**RE: Stormwater Review  
15 High Street Comprehensive Permit  
Norwell, Massachusetts**

We offer the following responses to the Plan Review, Comprehensive Permit – 15 High Street, Norwell, MA performed by Chessia Consulting Services (CCS), LLC, dated July 12, 2021. Revised Site Plans and a Stormwater Management Report for the above referenced project will be provided separately. Our response will follow the format presented in the CCS review.

**RE: Field Infiltrometer Tests – August 27, 2021  
Proposed Infiltration Area  
35 High Street, Norwell, MA**

FIG. 1

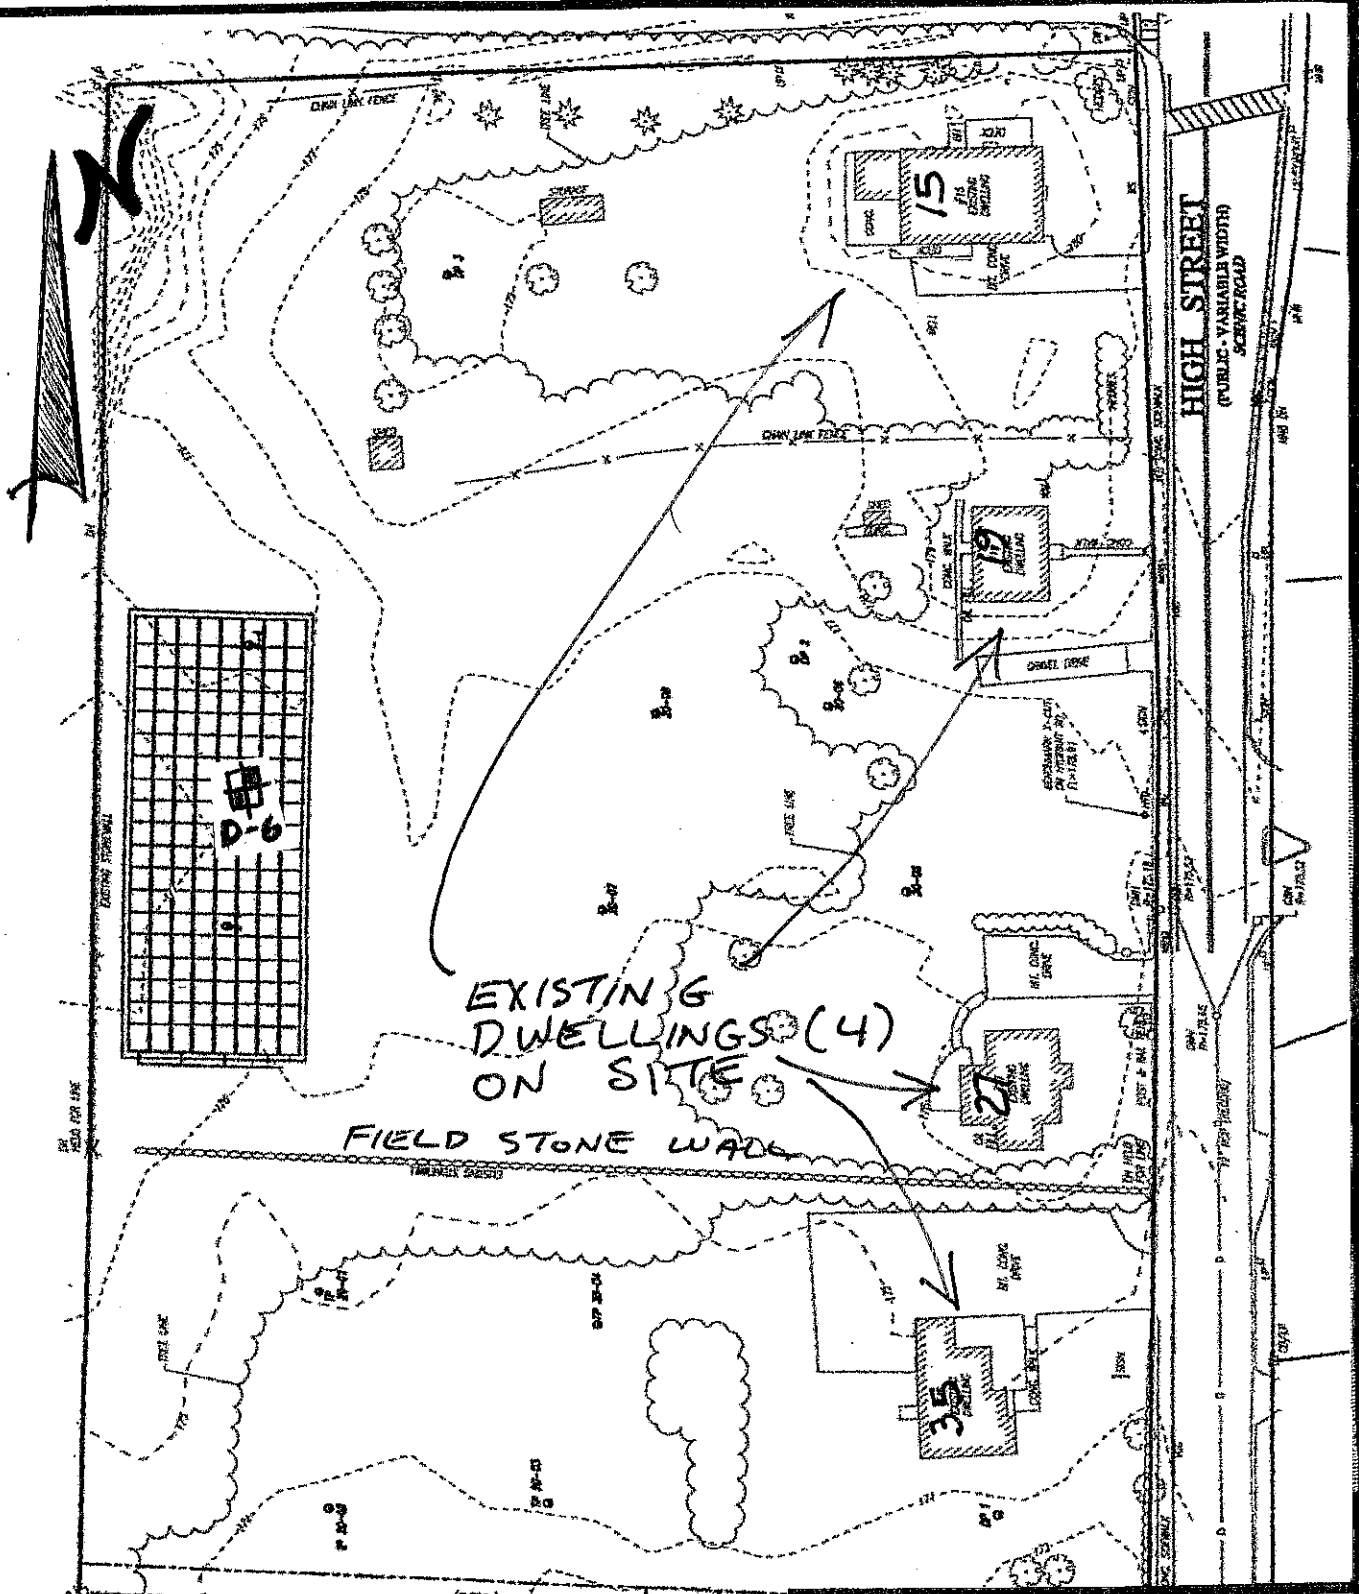
A single test pit was excavated about 12 feet below current site grade within the proposed infiltration area. The test pit is labelled D-6 by Merrill and is located on the attached Figure 1. The excavation extended through topsoil and subsoil into undisturbed gravelly sands with trace silt content based on textural examination by Briggs.
